Access Compliance Report

Public Rights-of-Way

Intersection ID: 29174	Main Street: BIG_LEAF_DR	Cross Street: CHRUDAN_DR	Location: NE
ADA ID: 3049E6FDA2B	Ramp Type: PerpDiag	Initial Pass/Fail: Pass	Overall Compliance: No
Codes/Mitigation Info/Possible Solution		Field Measurements/Component Compliance	
Severity Score: 2.75

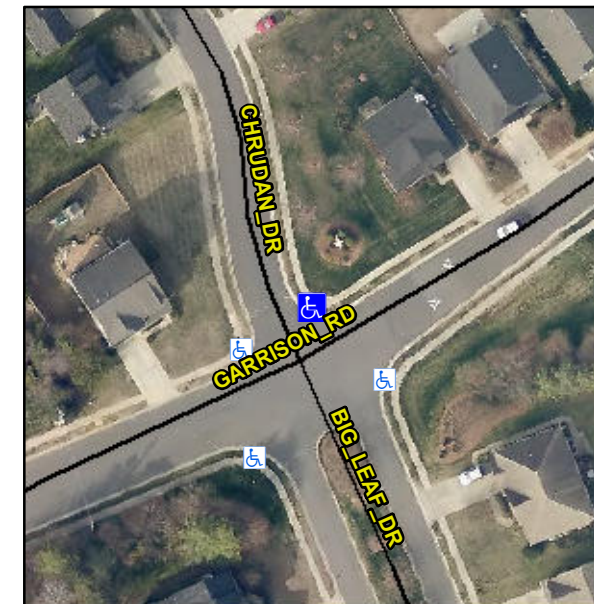
R304.5.3, R304.2.1, R304.2.2-Perp, R304.3.2-Para, R305.1.4, R305.2

Compliance	Description	Data	Compliance	Description	Data
N/A	Ramp Length (in)	96.0	Yes	Ramp Slope (%)	5.7
Yes	Ramp Width (in)	48.0	No	Ramp XSlope (%)	2.5
N/A	Flare Type LT	Sloped	N/A	Flare Type RT	N/A
N/A	Flare Slope LT (%)	5.9	Yes	Flare Slope RT (%)	8.6
N/A	Flare Traversable LT?	Yes	N/A	Flare Traversable RT?	Yes
No	Landing Length (in)	46.0	Yes	DWS Provided?	Yes
Yes	Landing Width (in)	52.5	Yes	DWS Contrast?	Yes
No	Landing Slope (%)	5.3	Yes	DWS Length (in)	25.5
Yes	Landing X Slope (%)	1.0	No	DWS Full Width?	No
N/A	Landing Curb? (Y/N)	No	No	DWS Offset (in)	3.0
N/A	Shared Landing?	No			
Yes	Gutter Ponding?	No	Yes	Gutter Slope (%)	1.0
Yes	Gutter Lip Ht (in)	0.0	Yes	Gutter X Slope (%)	1.8
N/A	Painted X Walk1?	No	N/A	Painted X Walk2?	No
	X Walk 1 Direction	To W		X Walk 2 Direction	To S
N/A	X Walk 1 Width (in)	N/A	N/A	X Walk 2 Width (in)	N/A
	X Walk 1 Slope (%)	2.7		X Walk 2 Slope (%)	6.8
	X Walk 1 X Slope (%)	2.5		X Walk 2 X Slope (%)	0.4

Remove & Replace Curb Ramp With Two New Directional Ramps or Equivalent.
